STEREO IMPACT

PROBLEM REPORT
PR-1004
SEP LVPS Middle FM1
2004-04-23

Assembly : SEP LVPS	SubAssembly : Middle Board
Component/Part Number: SEP_Middle_F001	Serial Number: FM1
Originator: Selda Heavner	Organization: U.C. Berkeley
Phone : 510-643-8640	Email : selda@ssl.berkeley.edu

Figure 1: SEP LVPS Middle board Schematic

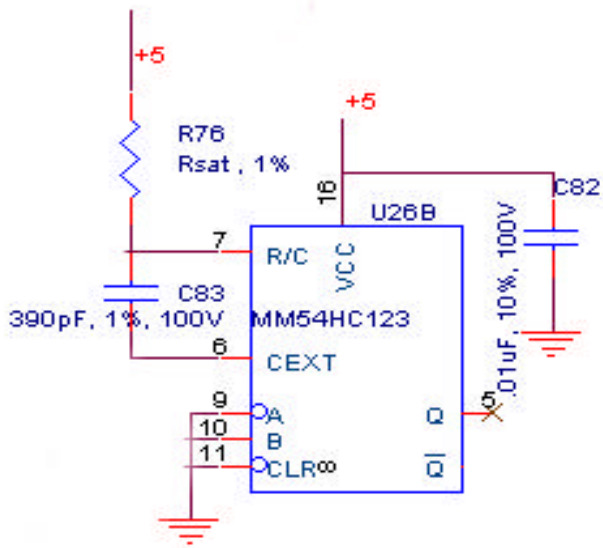
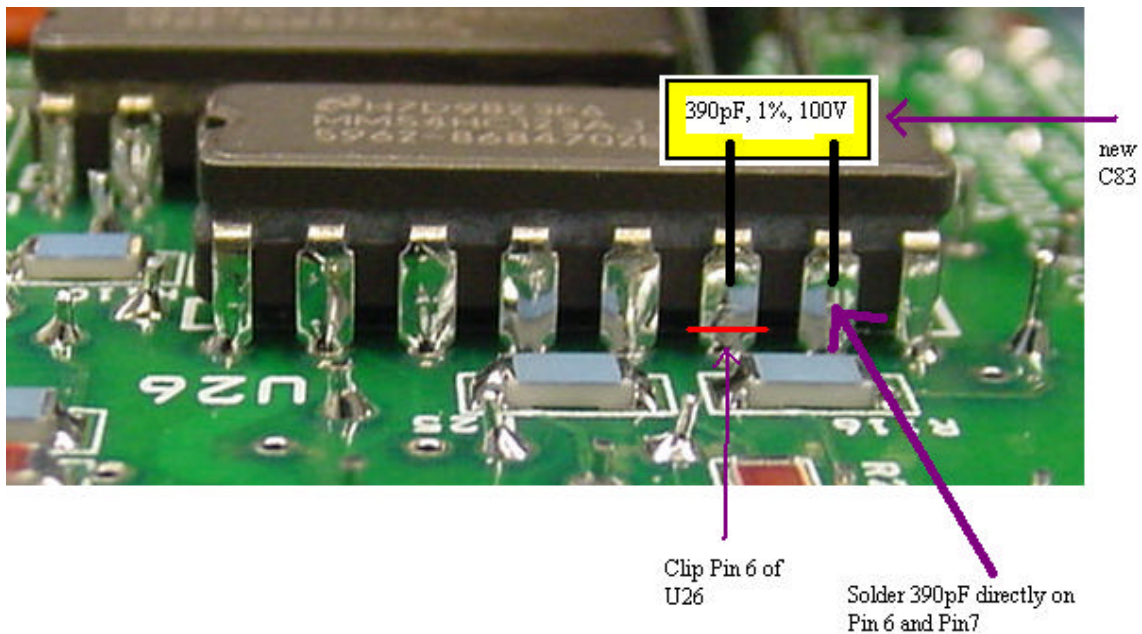
During first power-on of the SEP LVPS Middle Board FM1 the no output was observed at pin 12 of MM54HC123A (one-shot).

The layout is inspected. The capacitor C83 is supposed to be connected only to the Rsat and the Pin 6 of the one-shot. However Pin6 of the one-shot (U26) is also connected to Vcc due to an error in layout generating software.

1. Remove C83 (see page 2 of PR-1004 for figures)
2. Remove solder from Pin6 of U26.
3. Using an anti-shock cutter clip Pin 6 of U26 (stake the pad during staking process)
4. Solder a 390pF, 1%, 100V capacitor (CK05) directly onto the chip between pin6 and pin 7 of the one-shot (U26)

Note: Applying 5V to the MM54HC123A at CEXT is not detrimental to the circuit. CEXT can handle maximum of 6V.
